**Audio-Technica Corporation**  
**FCC ID : JFZATH-CKR75BT**  
**IC: 1752B-CKR75BT**  
**Part 15C Certification**

**Class II Permissive Change**

## A circuit difference between ATH-CKR75BT and AT-WLA1

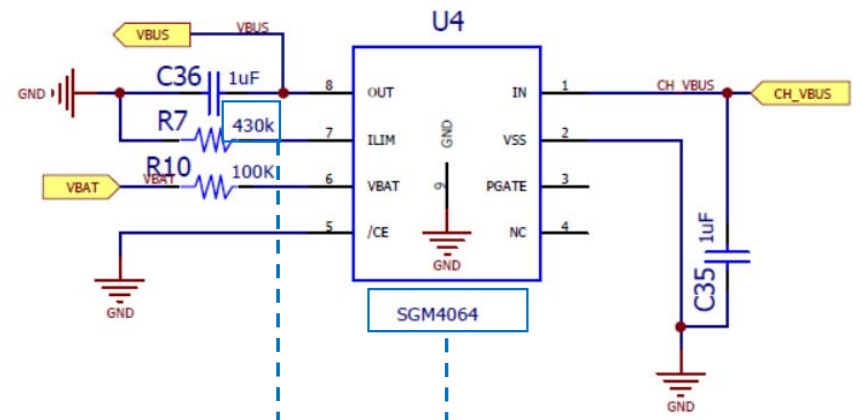
Parts of the U4(Protection IC) and R7(Protection Current Value determination Resistance) are different.

## The Mechanism difference between ATH-CKR75BT and AT-WLA1

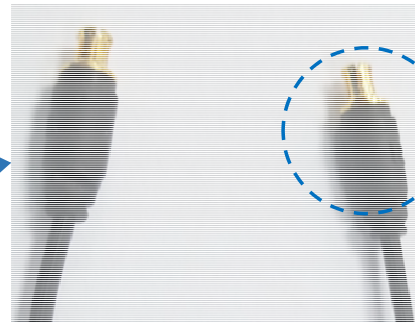
A2DC Jack

ATH-WLA1 Earphone Section Picture(Earphone Not included)

ATH-CKR75BT Earphone Section Picture(Earphone included)
